TRANS/WP.29/877  
24 July 2002

World Forum for Harmonization of Vehicle Regulations (WP.29)

DRAFT SUPPLEMENT 5 TO REGULATION No. 101

(Emission of CO<sub>2</sub> and fuel consumption measurement)

Figure 8/1: Parameters measured during carbon dioxide emission and fuel consumption test during and between cycles where regeneration occurs (schematic example, the emissions during 'D' may increase or decrease)

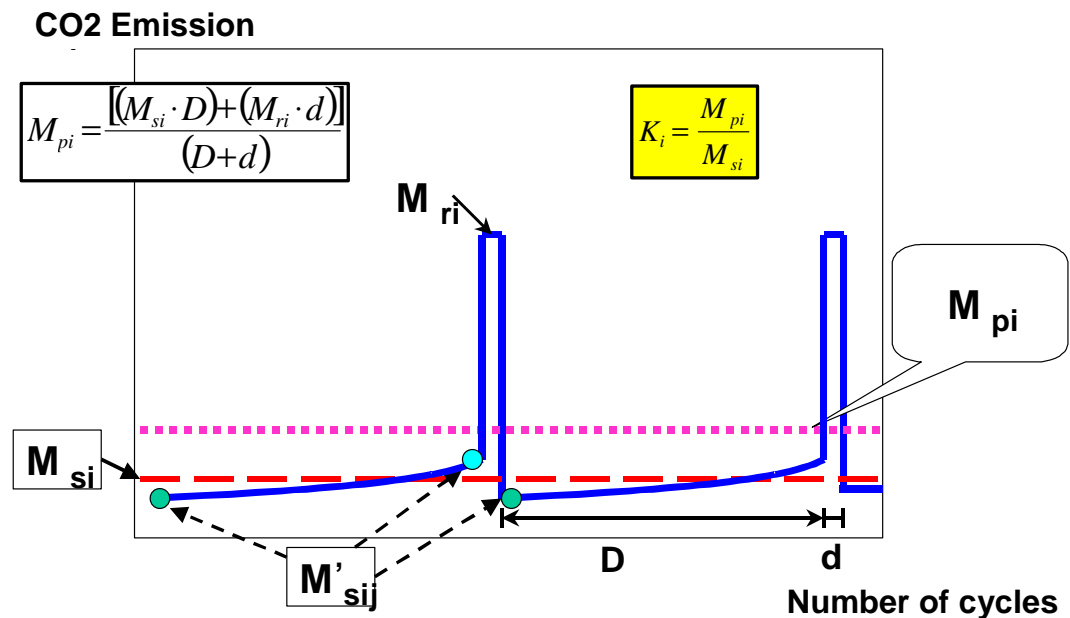
For exemplary illustration of measurement parameters see figure 8/1.

3.4. Calculation of the regeneration factor K for each carbon dioxide emission and fuel consumption (i) considered

$$K_i = M_{pi} / M_{si}$$
